**AP1000 Draft Safety Evaluation Report
LBB Open Items**

**Presentation to NRC Staff
Rockville, MD**

July 11, 2003

Figure 8.6.1 AP1000 Bounding Analysis Curve for 8" CMT DVI IRWST
(Line Numbers: L015A,016A,018A,020A,021A-No Insul.,025A,125A,127A)

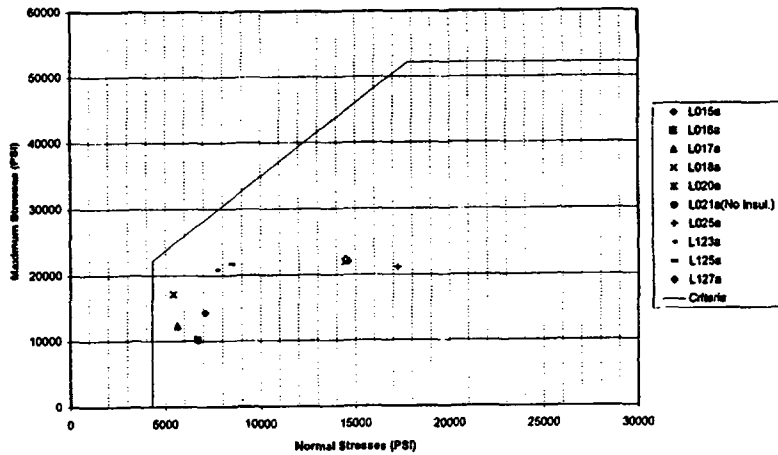
- **Piping stress analysis for AP1000 candidate system in-progress**
- **DVI-A Piping Analysis Package**
 - Selected based on our experience with AP600
 - Difficult to qualify
 - Complicated piping system
 - Some piping sizes were changed
 - Contains smallest piping line qualified for LBB
 - Subcompartment pressurization impacts if line would not meet LBB criteria

- **SECY-02-0059 Approved DAC Approach for Piping**
 - Design Acceptance Criteria in lieu of detailed piping design and analysis
- **W approach specifies that piping stress analysis be completed as part of COL application**
- **AP600 piping stress analyses can be used to demonstrate feasibility for AP1000**
- **AP1000 piping stress analysis for DVI-A further demonstrates feasibility**
- **No additional piping analysis required**
